Site Address: **1125 VALLEJO WY SAC**

re: Job 2002515: Whisenhunt residence located at 1125 Vallejo Drive, Sacramento, CA

subject: Contract Change Order Number 1

subject: Contract Change Order Number 3

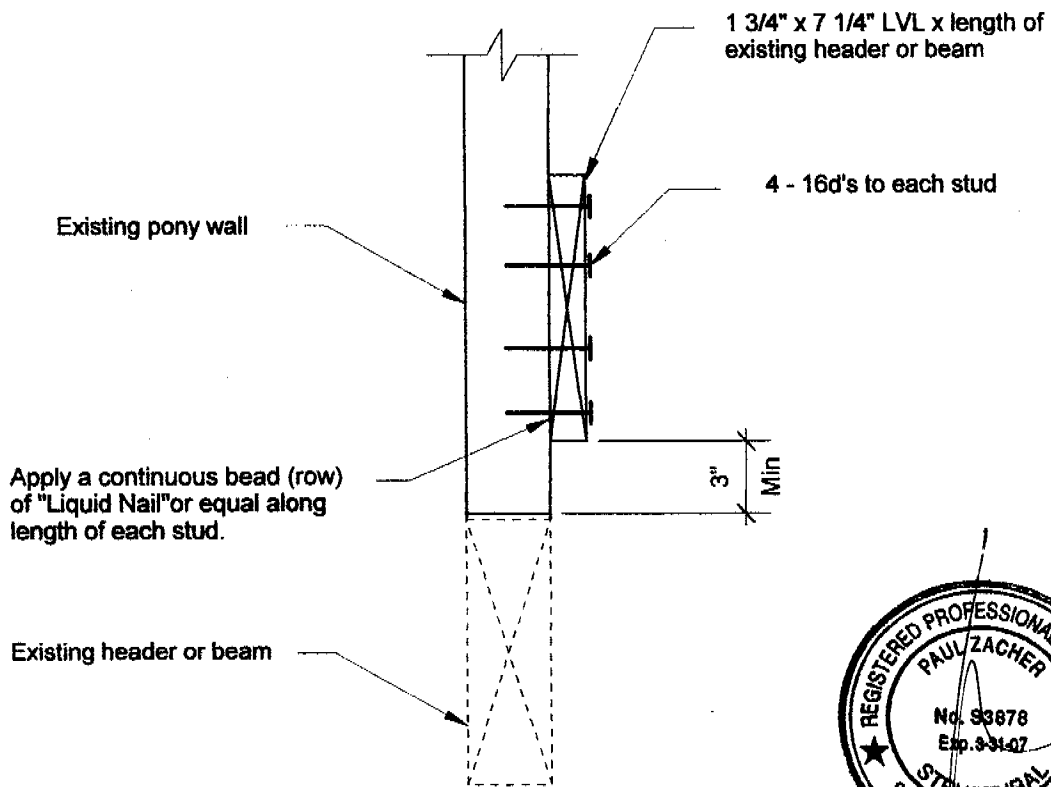
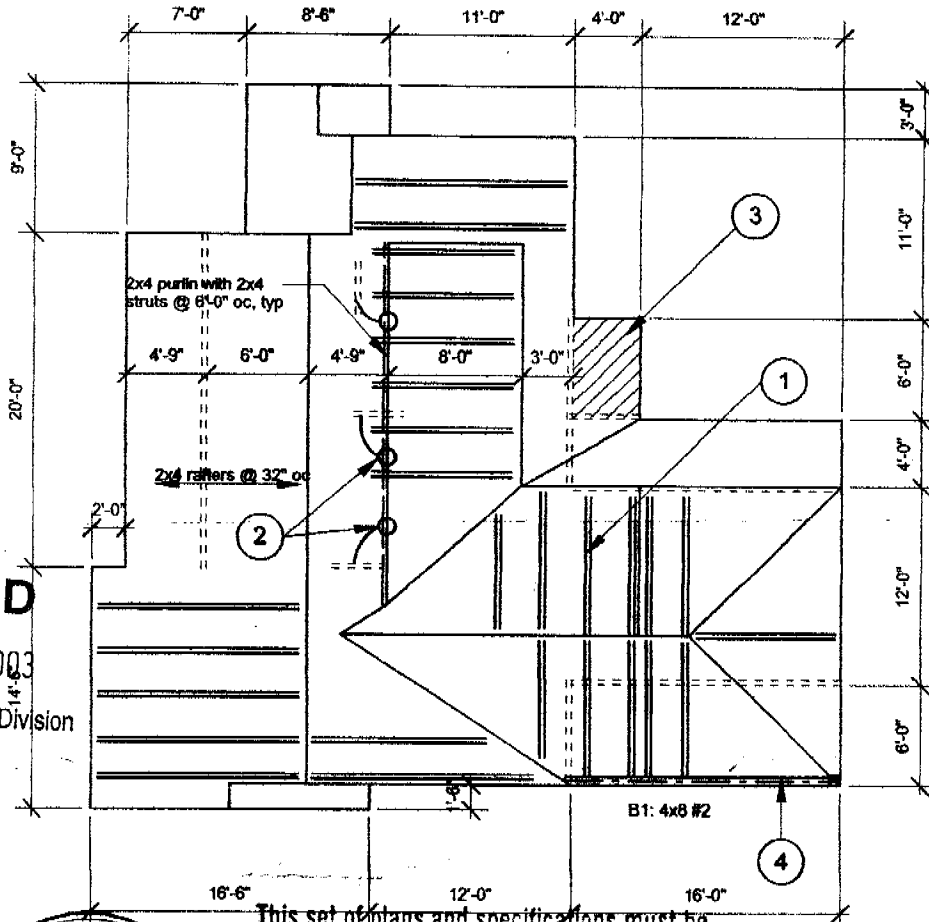
Item 1: The beam to be scabbed to beam 1 next to garage has been revised per the attached details 1 and 2.

1. Scab a 2x4 to existing 2x4 rafters where the span is greater than 7'-4" (total 18). Scab a 2x6 to existing 2x4 rafters where the span is greater than 9'-4" (total 2). Scab a 2x10 to existing 2x4 rafters where the span is greater than 12'-4" (total 7).
2. Add 2x4 struts to bearing below (total 3).
3. Remove the existing porch overhang.
4. Scab a 1 3/4" x 7 1/4" LVL to the existing 4x8 beam. See detail 2.

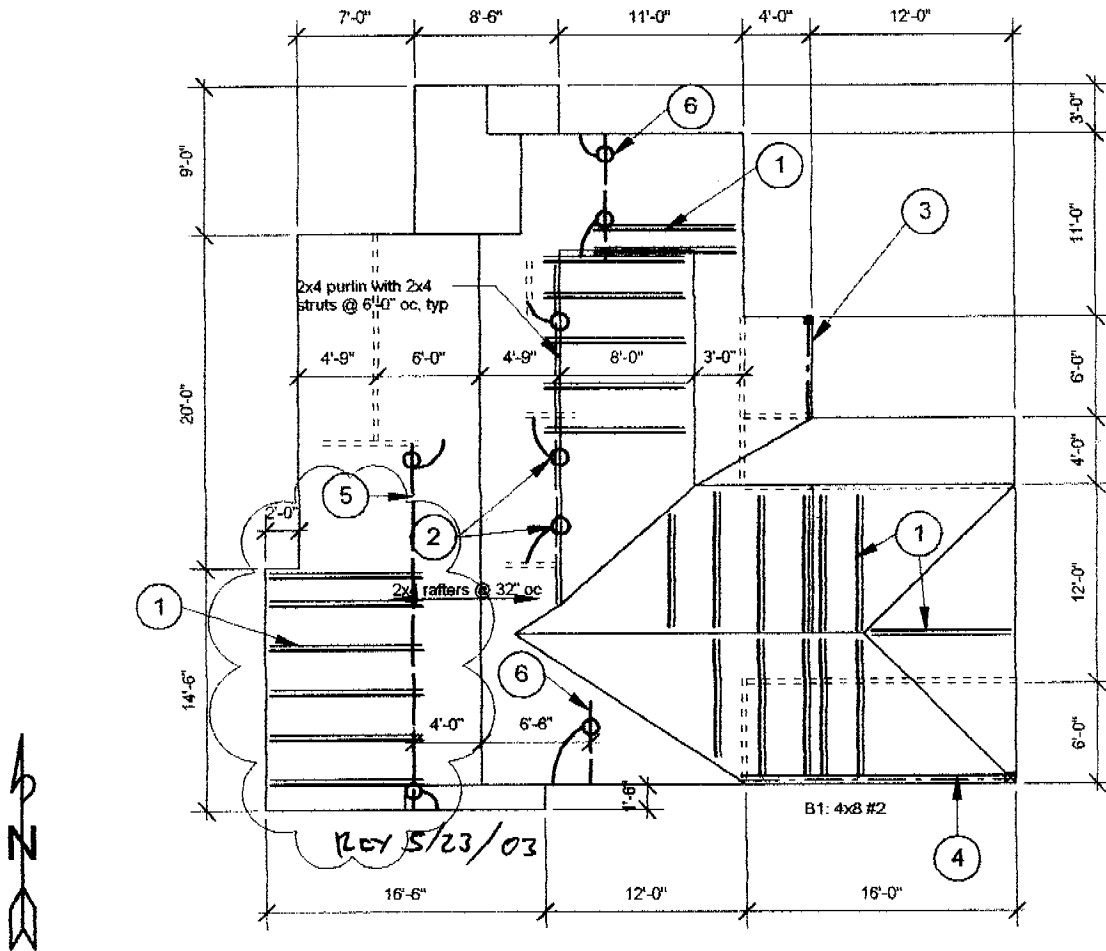
Item 1: The 1-3/4" x 14" LVL purlin is placed 4'-0" off the ridge rather than the 7'-0" as shown on CCO 02. Therefore, the 2x4 rafters spanning from the LVL to the exterior bearing wall are approximately 9'-6" in length. ~~Therefore, scab a 2x4 to the existing 2x4 rafters in this area. See the attached detail T.~~
